Assessment of the feasibility and potential of the Lilium urban air vehicle concept

This report represents a scientific analysis and assessment of the Lilium urban air vehicle concept, which is an electrically driven distributed, impeller (ducted fan) based concept.

The analysis was performed for Iceberg-Research and is based on a Lilium White Paper, [1]. Referring to information of Lilium, the White Paper represents a technical status of end of 2020 and has not yet been updated.

Figure 1: ducted fan orientation in hover, transition, cruise, [20]

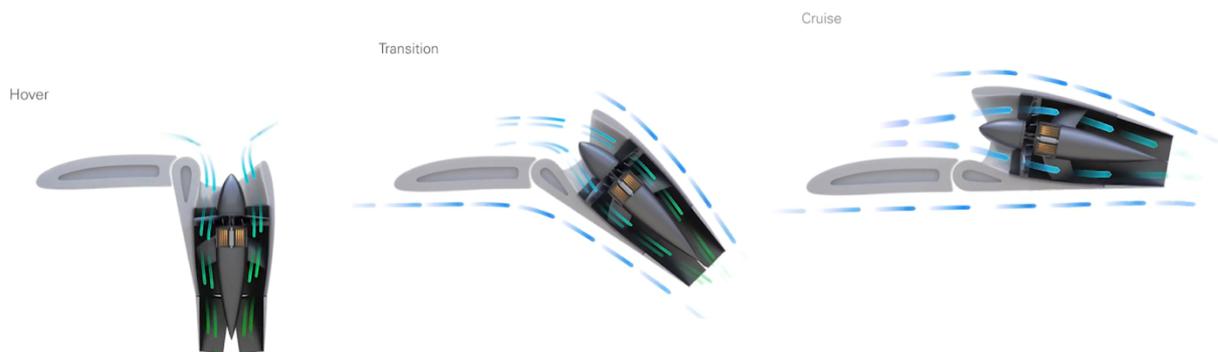
For the **transition phase** in **section 3.3** the situation is discussed. The transition phase is a crucial flight state at low speed between 0 to x kts forward speed, where the wing is taking over a measurable portion of the lift force, which is driven by the squared horizontal speed portion V_{hor}^2 .

At 45° tilt of the fan, 0,707 of the vertical thrust is available only and must be compensated by the aerodynamic lift. That means, in this state the aerodynamic lift and the associated forward speed must contribute at least 30% of the vertical lift at canards and wing, if the flight path shall remain horizontal. The more the ducted fans are tilting, the more the related thrust vector is contributing to forward speed and therefore lift. It is not visible in the paper at which tilting position the wing and the canards will contribute to the lift. As mentioned above in this state the flow above the tilted ducted fans is completely stalled due to the high tilt angle (corresponding to a high local angle of attack at the ducted fan surface) as shown in the video.

with a reduction factor $\kappa=10$. It describes the required average power is about 0,55 ($=0,5 \cdot (1+0,1)$) of the required power in hover. At the beginning of the transition the thrust vector is slightly tilting and at small tilt angles the thrust is deflected being reduced in the vertical axes. This reduction must be substituted by additional power to compensate the mass at the same flight level. On the other hand, the resulting small forward speed is too low to create significant lift.

Consequently, at the beginning of the transition more rather than less power of stable hover power is required. Further in cruise condition conventional aircraft require approximately 30-40% of the take off power to overcome the aerodynamic drag and to create forward speed. Therefore, a decrease of power by 90% down to 10% in cruise as performed in the averaged calculation seems to be not logical. It must be proven, that the resulting forward speed generates sufficient lift in this condition, due to the short chord length at canard and main wing.
